To: T10 Technical Committee
 From: Rob Elliott, HP (elliott@hp.com)
 Date: 27 August 2005
 Subject: 05-305r0 SAS-2 Maximum SMP connection time

Revision history

Revision 0 (27 August 2005) First revision

Figure 4 — PL_PM (port layer phy manager) state machine (part 1)

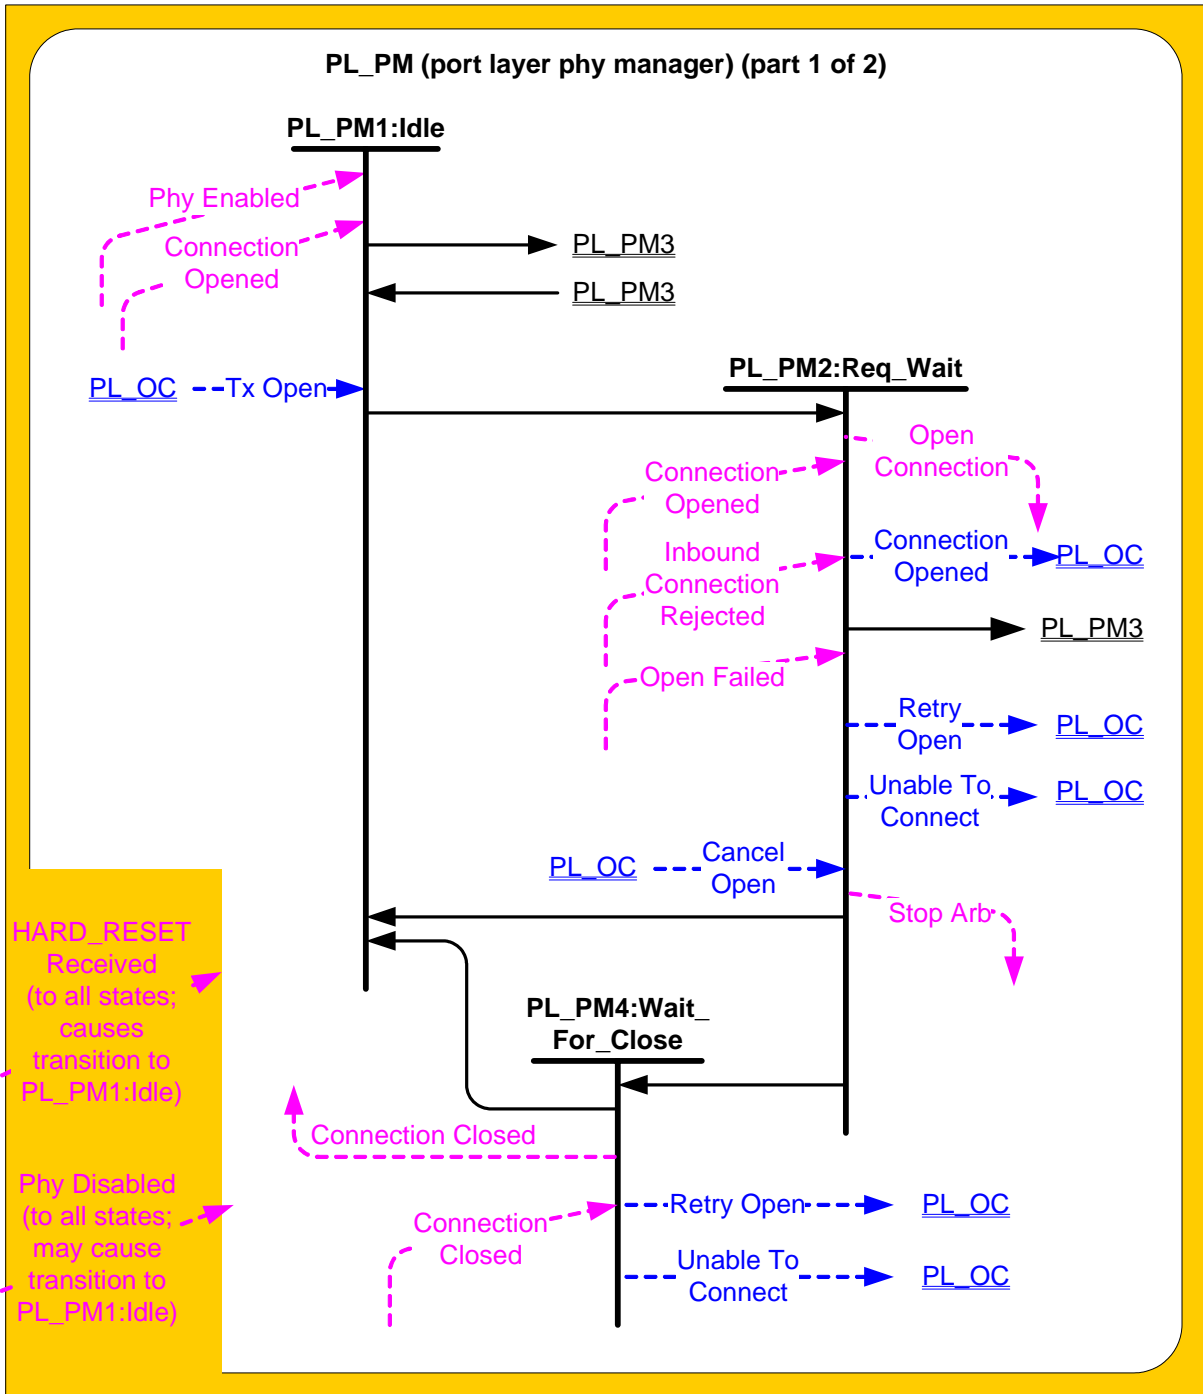
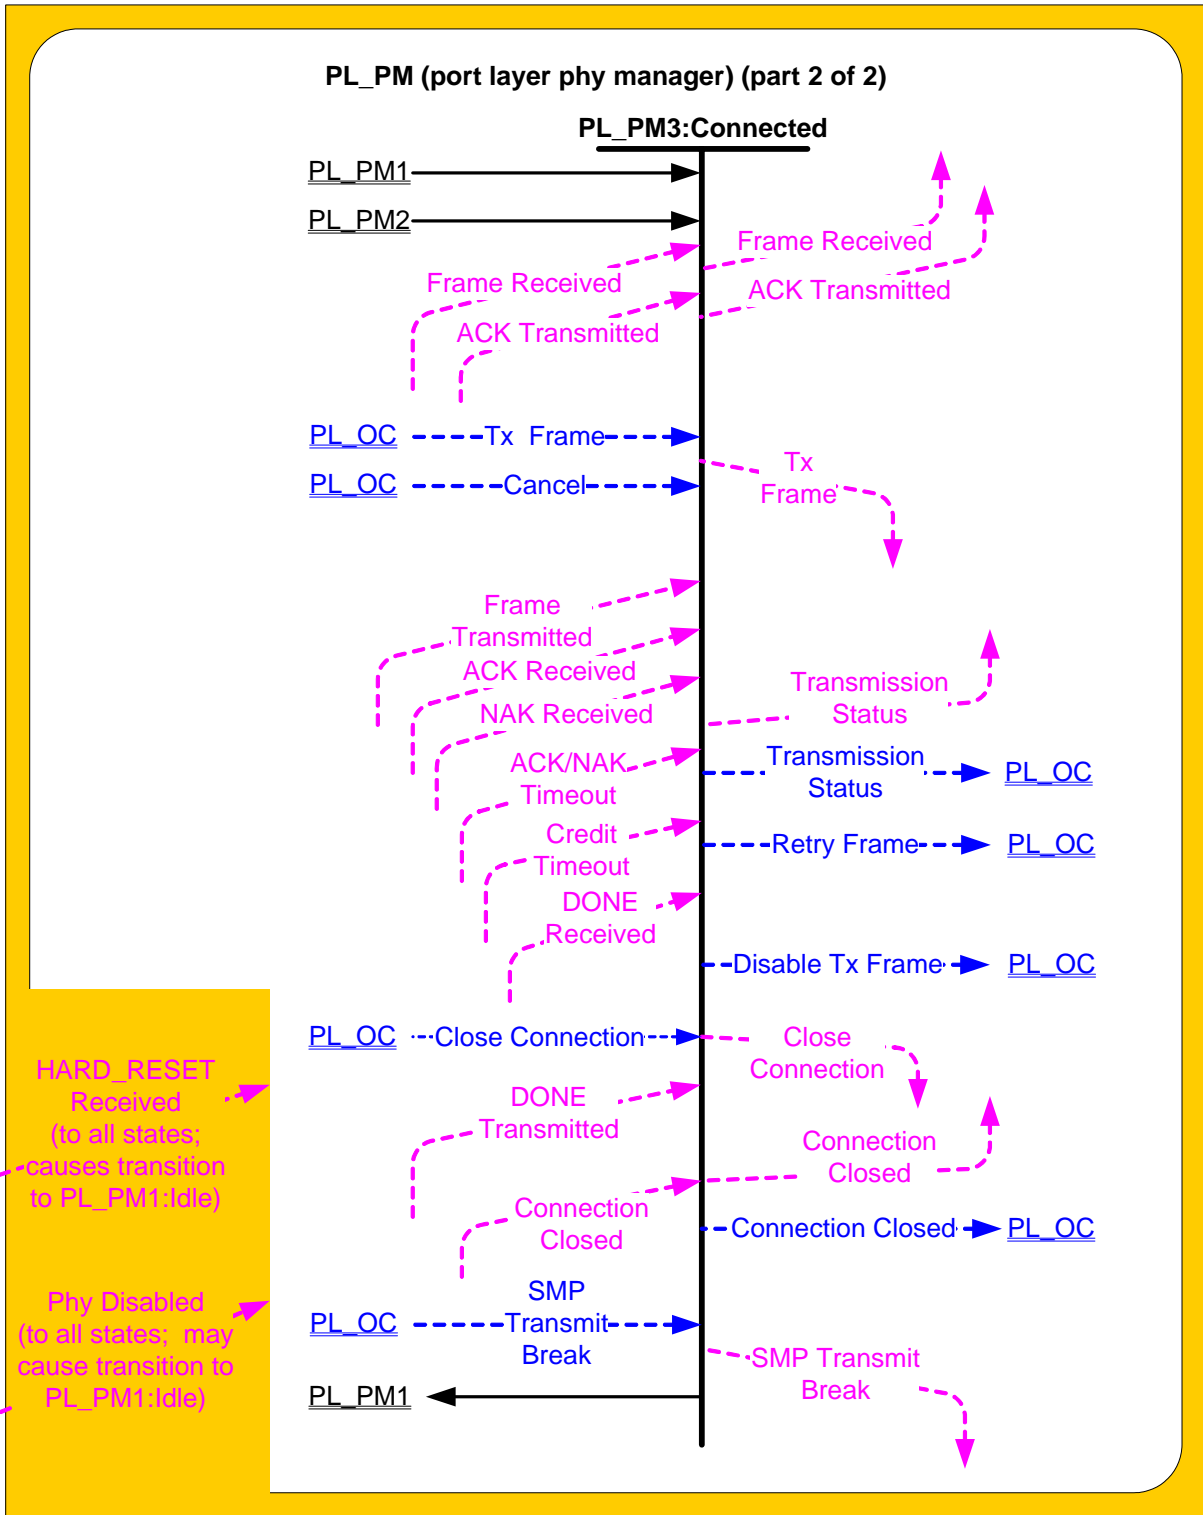
[If this state receives an SMP Transmit Break message, then this state shall send an SMP Transmit Break request to the link layer.](#)

[Editor's Note 6: SMP Transmit Break is in the figure but not in the text](#)

Figure 6 — MT_IP (transport layer for SMP initiator ports) state machine

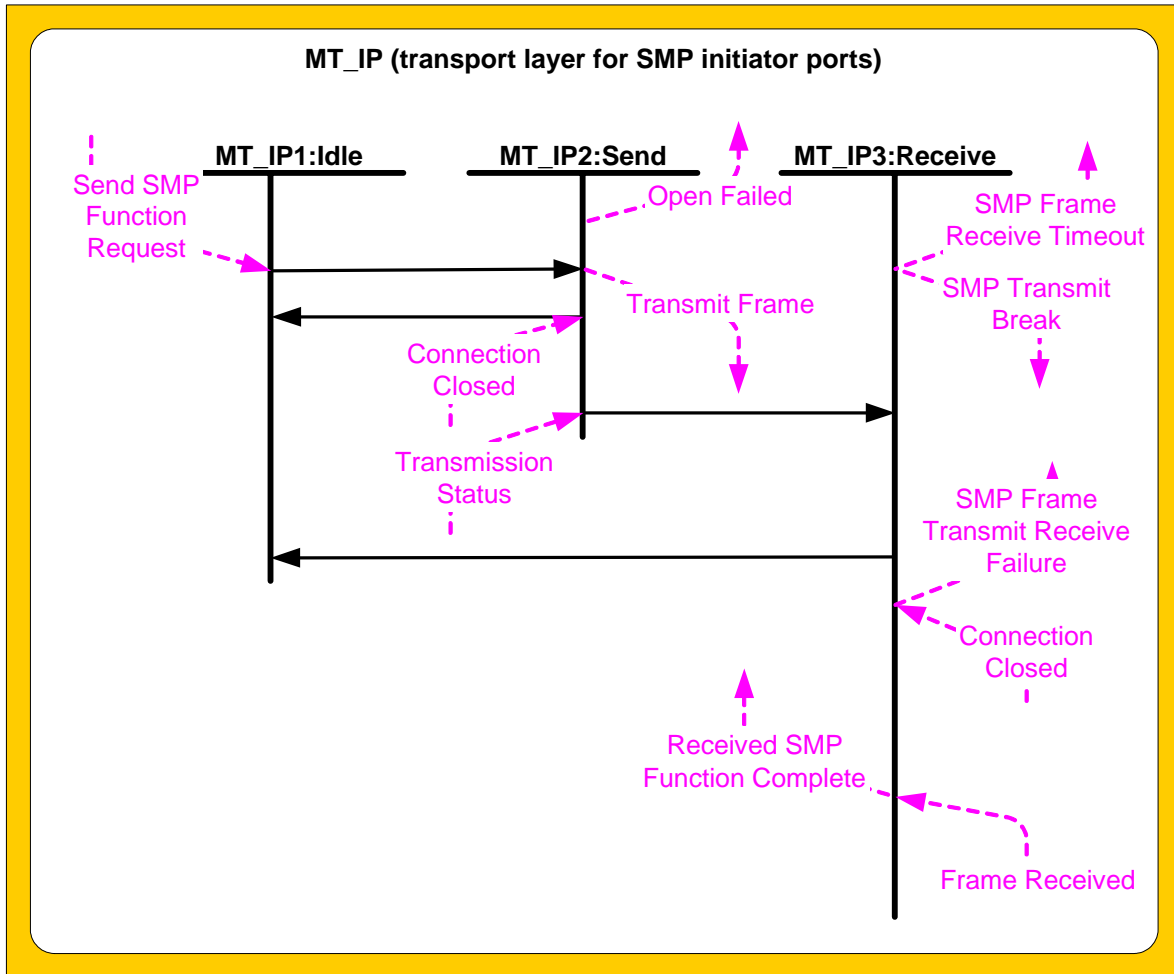
Editor's Note 8: Delete the SMP Transmit Break request from MT_IP3:Receive state
